VICKERY COAL MINE PROJECT

Submission of the Wando Conservation and
Cultural Centre Inc, Maules Creek

VICKERY COAL MINE SSD7480
Groundwater Assessment FIGURE 62

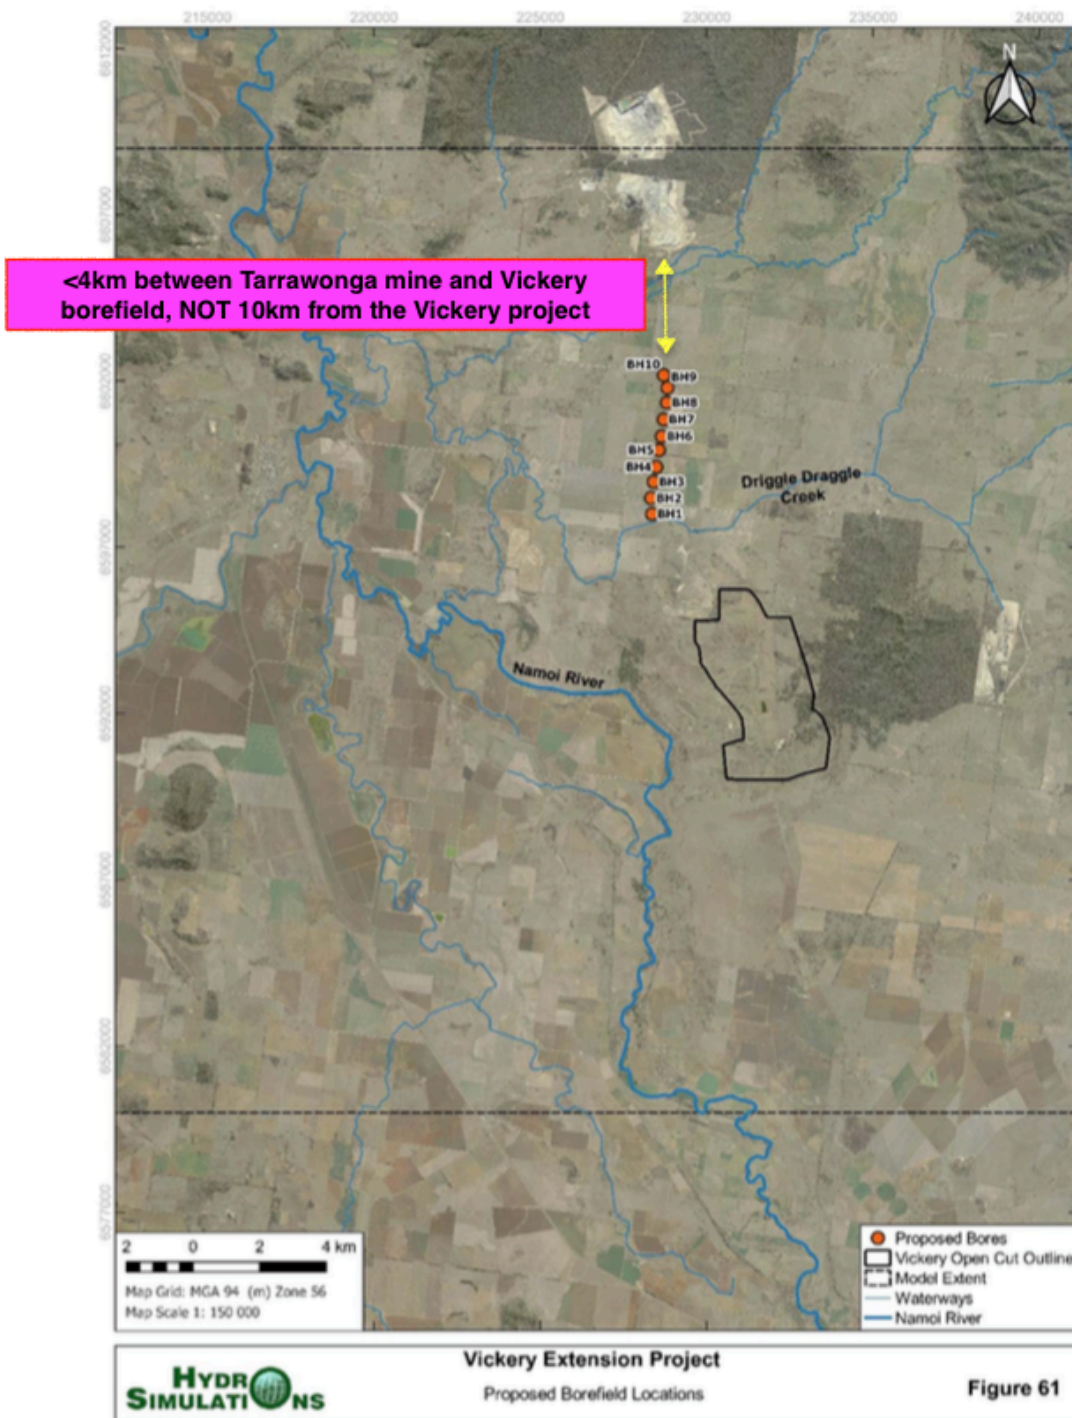
The potential cumulative impacts of four coal mines extracting a total of 35 MTPA within the relatively small region, and three Coal Handling and Processing Plants washing this quantity of coal, is being approached very lightly by the Vickery Extension EIS and Groundwater Assessment.

Maules Creek has current approval for 13MTPA but proposing to expand another 4 MTPA towards the North Exploration Licence A346 (with a stated determination to mine the EPBC-mandated East-West Biodiversity Corridor approximately 4 MTPA), Boggabri Coal (currently 8MTPA, and now also considering mining the EPBC-Biodiversity Corridor), Tarrawonga (4MTPA) and Vickery (10MTPA now, and further 4 MTPA in the Vickery State Forest).

In addition, there are numerous other Exploration Titles to the East of the Leard State Forest (Goonbri), North and in between Vickery and the Leard mines.

This massive mining region should be considered holistically, not in a piecemeal and fragmented manner.

This should be done before any further consideration is given to the Vickery Extension Project.
